MEETING DATE: February 25, 2026
TO: Planning Commission
STAFF ORIGINATOR: Steven Gilmore, AICP, Assistant Community Development Director
AGENDA ITEM: PUBLIC HEARING - Hidden Creek South Preliminary Plat and Planned Unit Development
60-Day Deadline: April 21, 2026

Headwaters Land Group, represented by Mr. John Dobbs, has submitted applications for a Preliminary Plat and Planned Unit Development (PUD) Amendment for Hidden Creek South. The subject property consists of approximately 56.52 gross acres located south of Headwaters Parkway within the Headwaters Master Planned Unit Development (PUD) area.

We provide the following comments for the proposed improvements:

PRELIMINARY SITE & UTILITY PLAN

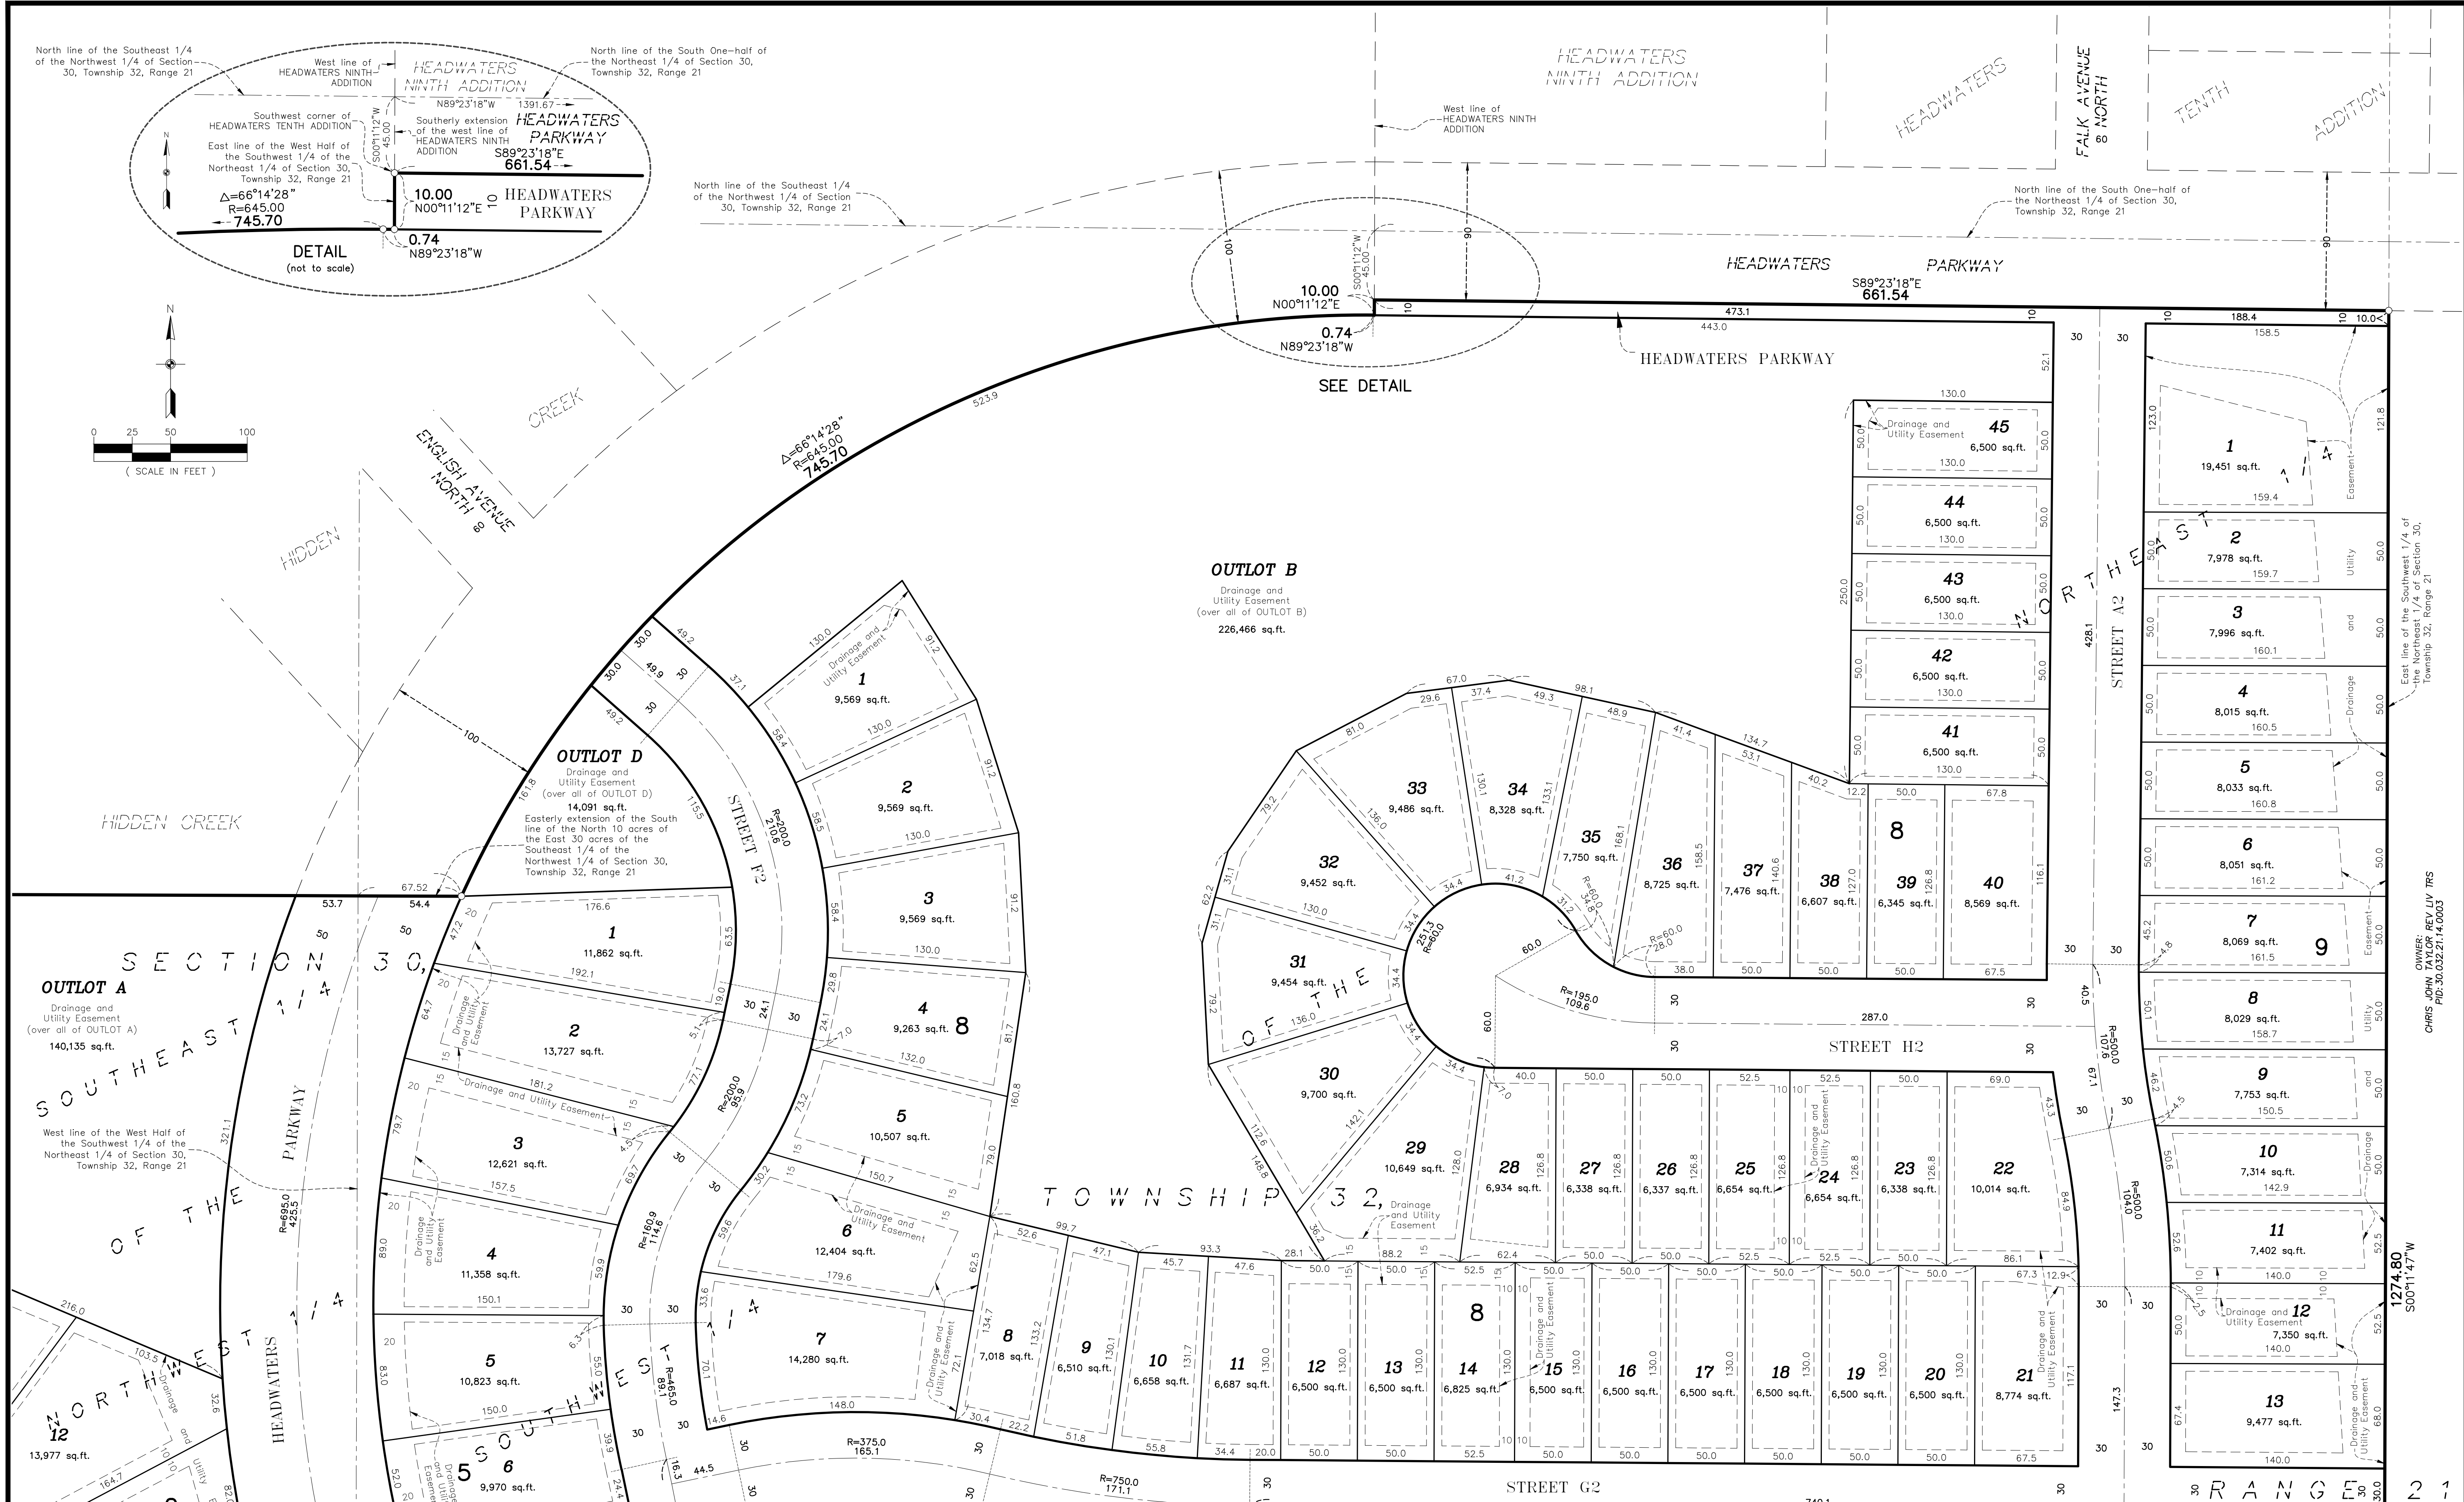
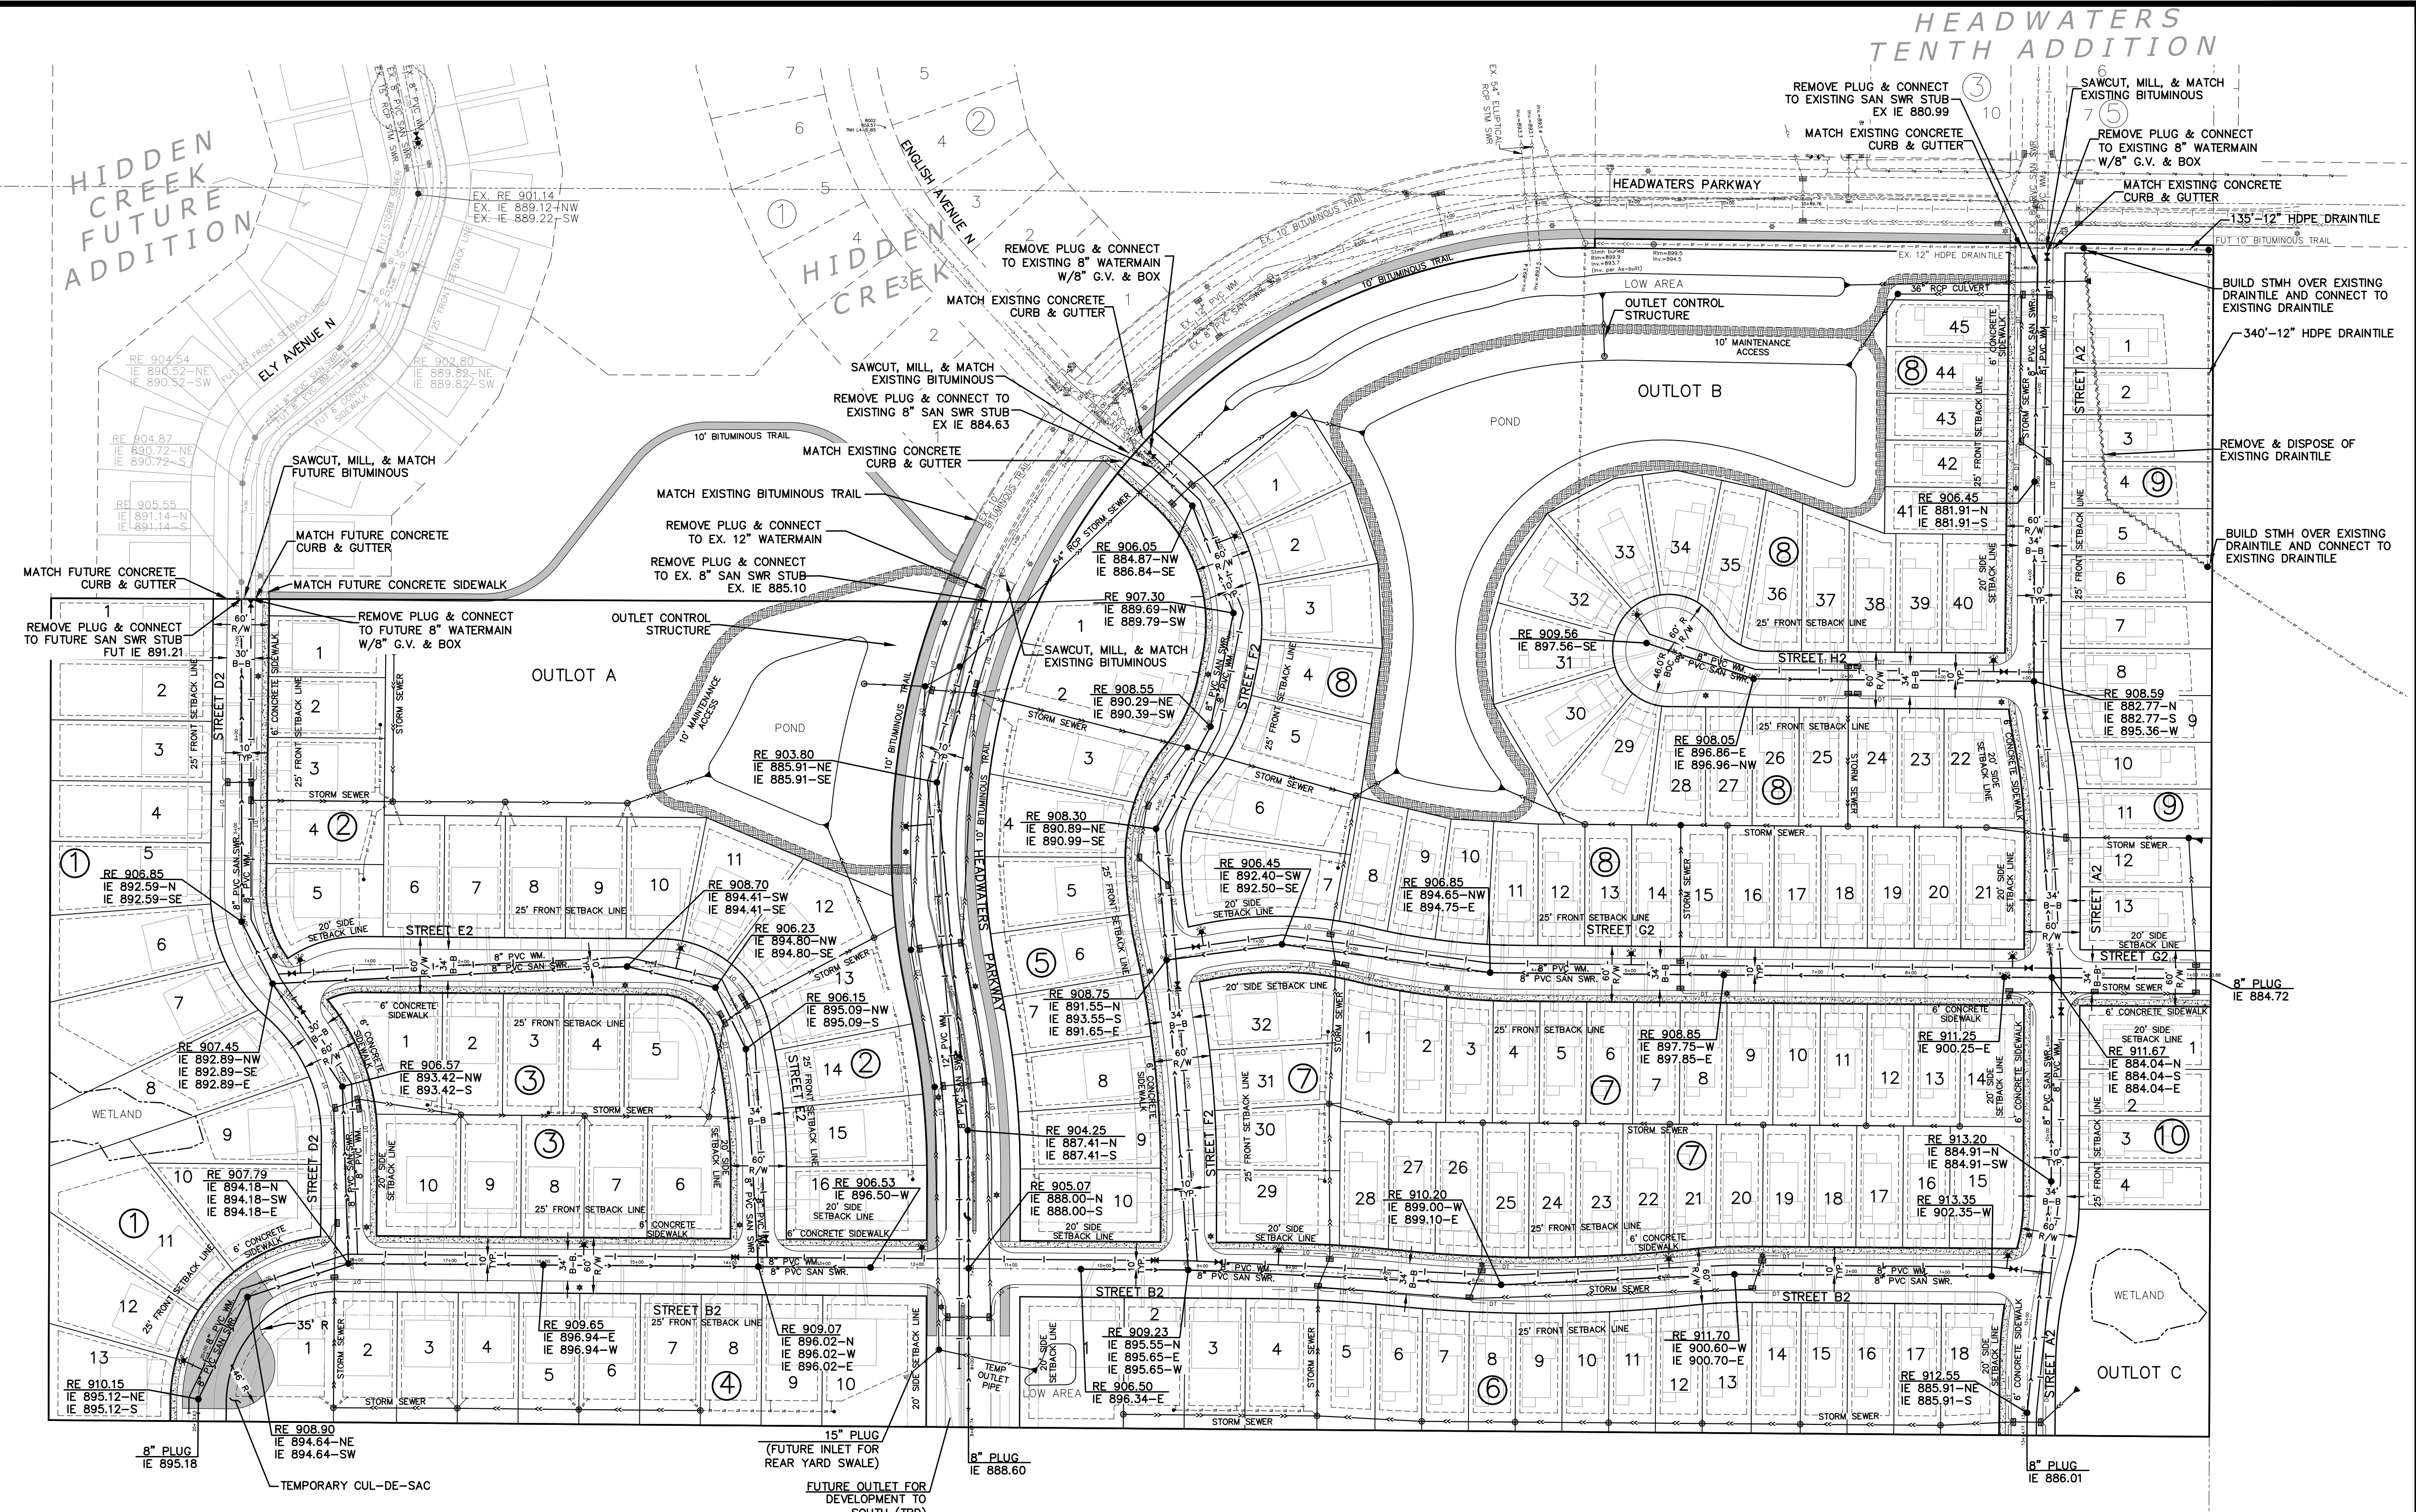
20. Sanitary sewer and watermain testing will be required per the current Forest Lake Public Works/Engineering Standards.
21. Sanitary sewer and watermain alignments may need to be adjusted if additional storm sewer runs are added to meet spread requirements.

22. Provide 50 scale plan/profile view sheets for proposed sanitary sewer and watermain, show storm crossings and sanitary service risers and heights in profile views.

23. Add labels for sanitary manhole/pipes (Rim, Inverts, Pipe Size/Slope/Material), hydrants, valves, fittings (tees, bends, plugs), and watermain pipe size/material.

24. Show proposed elevations for sanitary (invert) and water services (finished grade at curb box) and sanitary service wye stationing from downstream manhole for each lot.

25. Revise sanitary sewer and watermain layout as noted on the attached markup.
26. Obtain permanent easements on adjacent properties to extend sanitary sewer and watermain stubs as noted on the attached markup, to allow construction of the street to the plat line and prevent damage to the street when utilities are extended in the future.

27. Provide sanitary sewer and watermain services to Park area on Outlot A as noted on the attached markups.
28. The proposed 0.1-foot drop across manholes is not desired by the City for the sanitary sewer mains, revise as noted on the attached markups.

29. Revise sanitary manhole inverts as noted on the attached markup to eliminate conflicts (and provide min. 1.5' separation) between sanitary services and watermain at the upstream ends of the sanitary runs.

30. For outside drop manholes:
 - a. The first 20' (or 2 times the drop depth, whichever is larger) shall be ceramic lined DIP or PVC C900 DR 18 per City Detail SAN-3. Label drop depth on plan/profile.

- b. The interior of drop manholes shall be lined with Zebron, Spectrashield, or approved equal per City Detail SAN-3.
31. Coordinate any water shut downs with City staff a minimum of 72 hours prior to service interruption to allow for proper notification to the affected properties.

32. All watermain shall have 8.0' minimum cover.
33. Design watermain depth at hydrant locations to ensure hydrant extensions are not used.
34. Revise gate valve layout and hydrant spacing (250' radius to cover building pads) as noted on the attached markups.

35. Water services and curb stops shall not be installed in driveways or have planned landscaping near them.
36. Hydrants adjacent to sidewalks shall be centered 4' from back of curb to provide a minimum 1' clear zone from sidewalks, all other hydrants shall be centered 5' from back of curb.

37. Watermain stubs shall have plugs tapped with 1" corp, 1" curb stop, and 1" service pipe for watermain blowoff for flushing and testing.
38. Provide 50 scale plan/profile view sheets for proposed streets, including signing and striping.

39. Provide intersection and pedestrian ramp detail sheets.
40. Design parameters for street alignments and profiles are included in the attached markup.

43. Permanent barricades with "Future Road Extension" signs are required at all stub street locations per City Details STR-11/STR-12.
44. Provide temporary barricades at Ely Ave N (Northwest side of development) until base course of pavement is completed.

45. Revise Street H2 cul-de-sac to meet City standard of 51' radius to back of curb.
46. Revise sidewalk and street light locations as noted on the attached markup.
